Subject: [FIXED] Beam pipe valves?

1) [viewer.gif](#), downloaded 1125 times

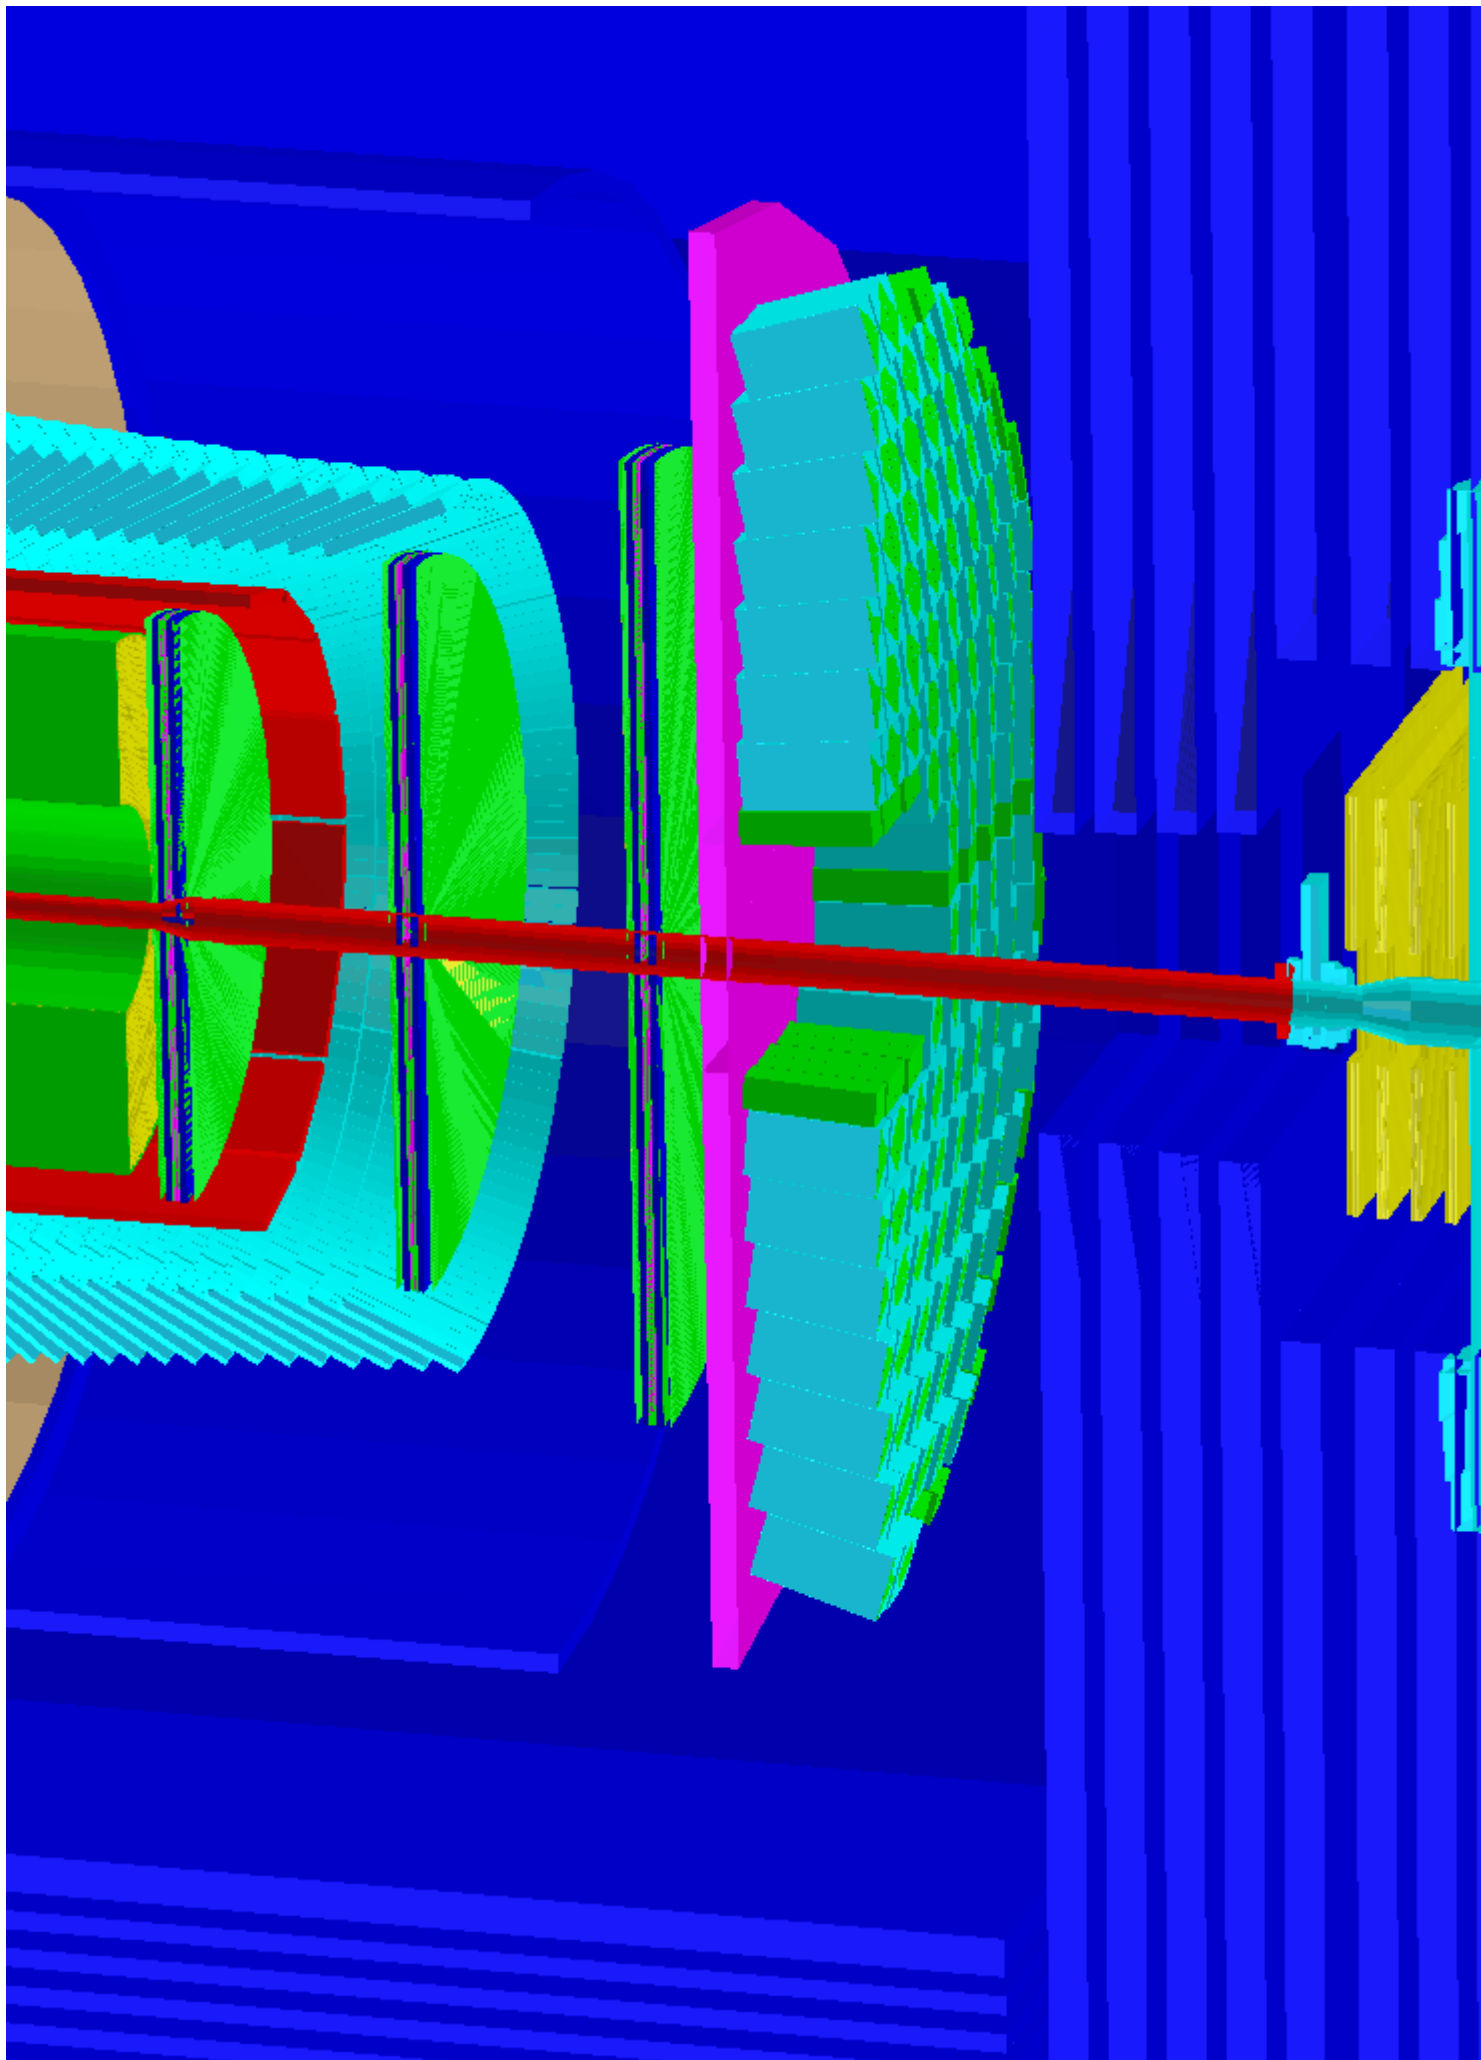
Dear all,
today I plotted the PANDA geometry and I have seen something strange:

In the OGL drawing you can see that the pipe has a sort of "tower" which is in the middle of the muon filter. I am wondering what is wrong there, if the "tower" should be really there, if maybe the muon filter should be modified to host it, or if maybe we have some geometry problems.

Indeed, this is the first pumping station downstream of the target. The description corresponds to what is to be found on EDMS since several years. So I guess that muon description is not up to date?

Fixed!

Please update your mdt folder, in particular those running analysis on forward tracker.
